**New Reactors Division**

**Step 4 Assessment of Fuel & Core Design for the UK Advanced Boiling Water Reactor**

Report ONR-NR-AR-17-019  
Revision 0  
December 2017

Figure 1, Cladding Failure Modes

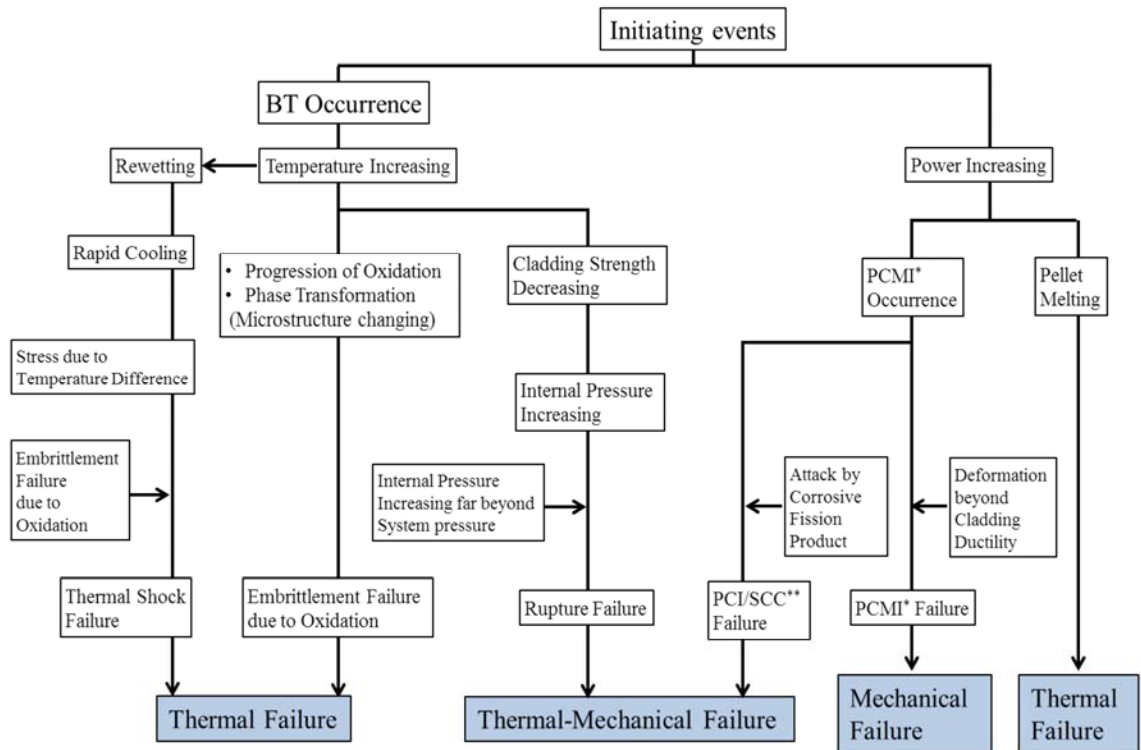
177. After several iterations, Ref. 42 provides a systematic and concise justification of the design criteria used in analysis of fuel integrity. I commend the clarity provided in Figure 1.
178. I expect that in accordance with IAEA and WENRA requirements, these criteria should ensure that the fuel integrity is not threatened in normal operation and frequent faults and that, as far as reasonably practical, the cladding retains its confinement function in infrequent accident conditions.
179. My assessment of the completeness of these criteria has been based on consideration of guidance in TAG 75 and relevant practice elsewhere reported by the OECD working group on fuel safety in Ref. 16.
